| Intersection ID: 20630 | Main Street: COUNTRY_BARN_CT | Cross Street: EMERALD_MEADOW_LN | Location: | W |
| ADA ID: 0C7B5FCA150E | Ramp Type: PerpDiag | Initial Pass/Fail: Fail | Overall Compliance: No | Severity Score: 13.75 |

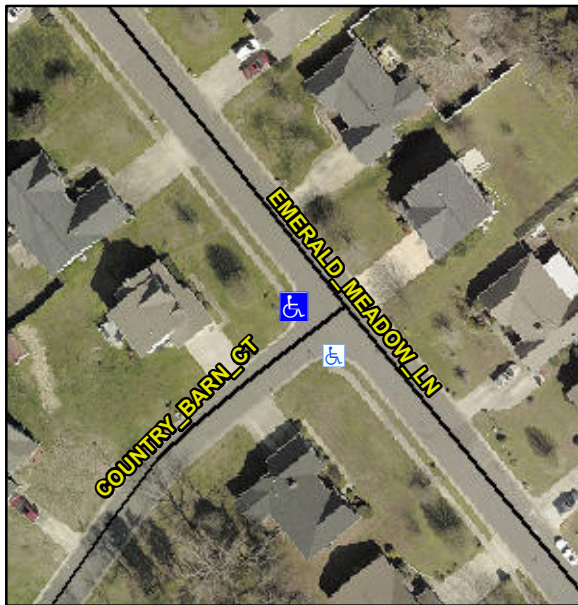
R304.2.2, R304.5.3

| Compliance | Description | Data | Compliance | Description | Data |
|------------|-----------------------|-------|------------|-----------------------------|-------|
| N/A | Ramp Length (in) | 48.0 | No | Ramp Slope (%) | 9.5 |
| Yes | Ramp Width (in) | 48.0 | No | Ramp XSlope (%) | 2.6 |

Remove & Replace Curb Ramp With Two New Directional Ramps or Equivalent.
